APPEAL SUMMARY

Appeal ID: 20721

Project Address: 1406 NE Holman St

APPEAL INFORMATION SHEET

Lobdell ADU Light Straw Clay Wall Detail *

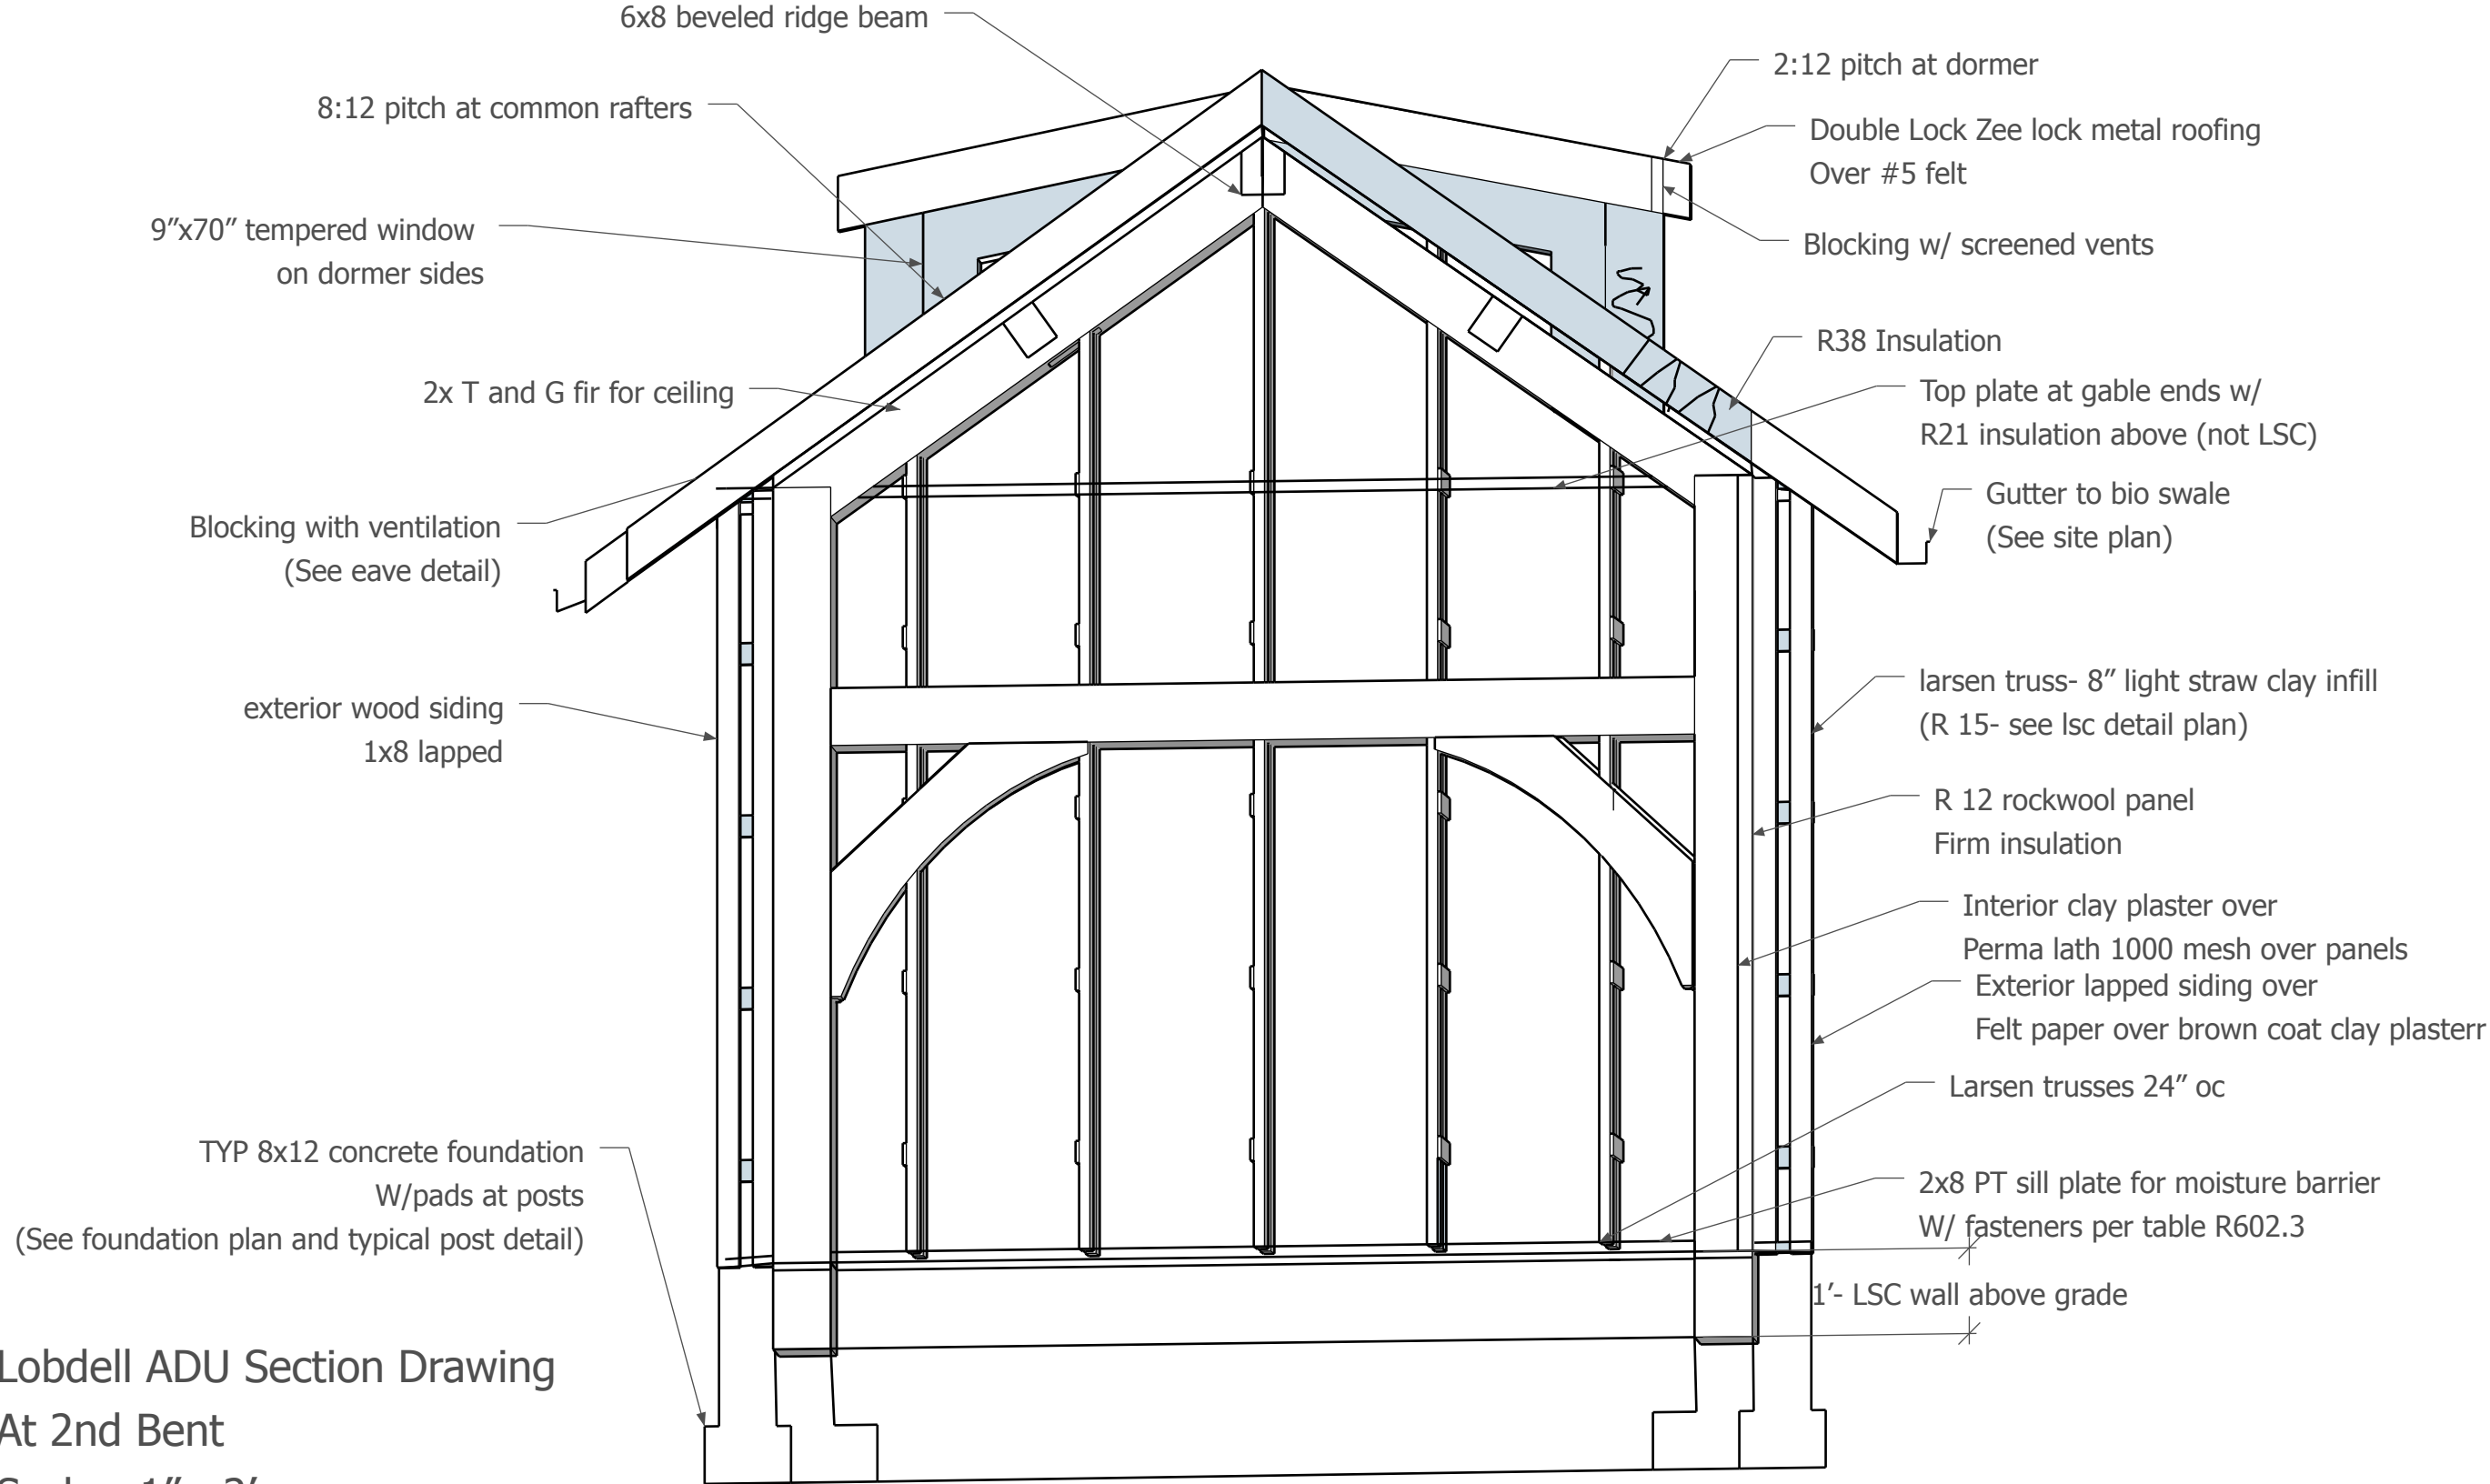
Proposed Design I am proposing the use of Light Straw Clay design for a 308ft2 ADU in NE Portland. This system will have an 8" wall (R-15) with an additional rock wool batting added (R-12) to meet the minimum R-21 requirements. These walls are non load bearing. The exterior will have building paper, under 1x10 lapped wood siding. The interior will be clay plaster over permalath 1000 over the rock wool sheets.

The thinner wall system, compare to the 12" wall that has been previously permitted, allows for quicker drying. Previous building projects prolong drying of the 12' wall and rotting has occurred.

1. Use of light straw clay construction with 8 inch walls as an alternate method: Granted as proposed.

Lobdell ADU Section Drawing
At 2nd Bent
Scale: 1": 2'

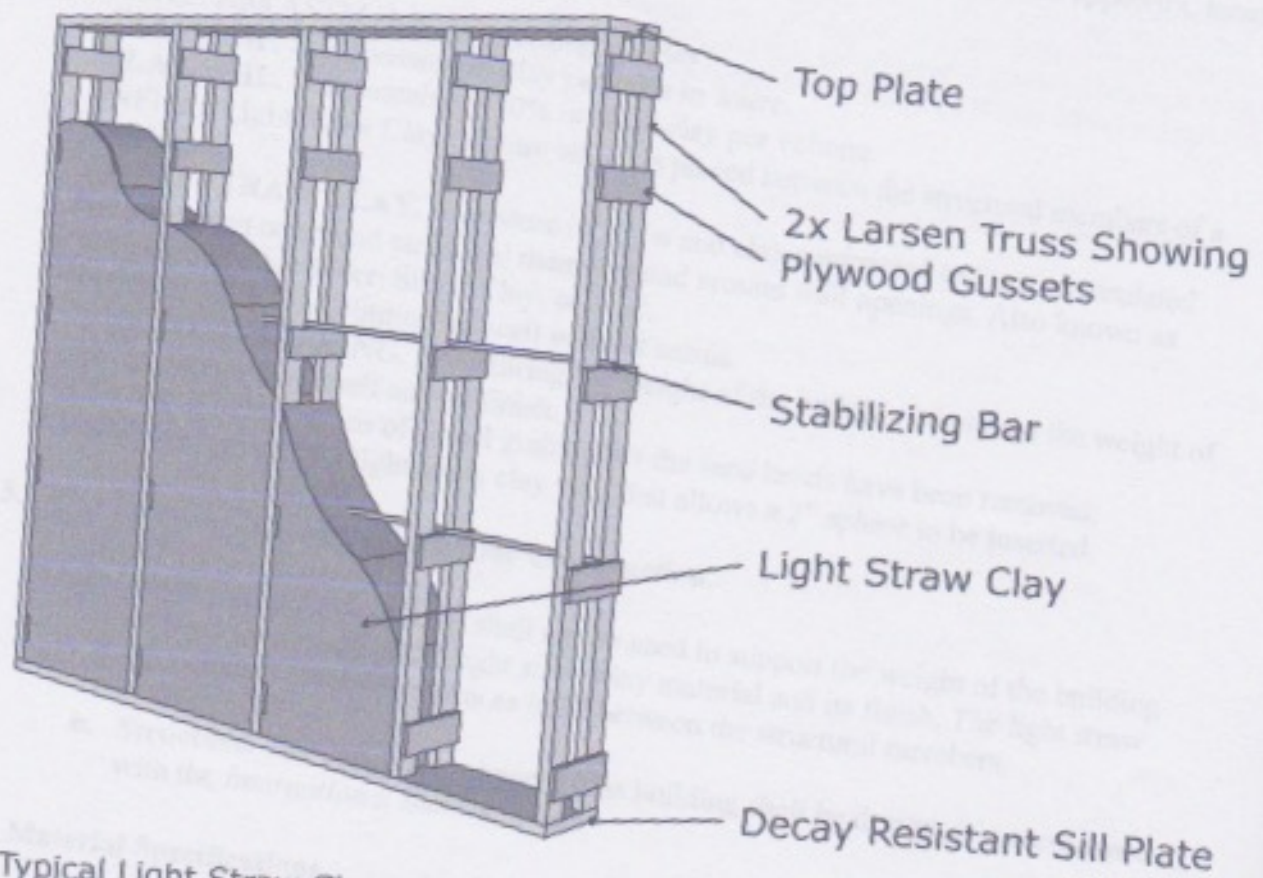
Proposed Design The Light Straw Clay design contains walls that are much heavier than conventional walls. The heavy timers are also very heavy. This adds to the seismic durability.

Please see files (ADU lateral load calcs) attached for more information regarding specific wall calculations.

2. Use of light straw clay construction in Seismic Zone D1: Granted as proposed.

Note: Structural calculations will be reviewed at time of plan review.
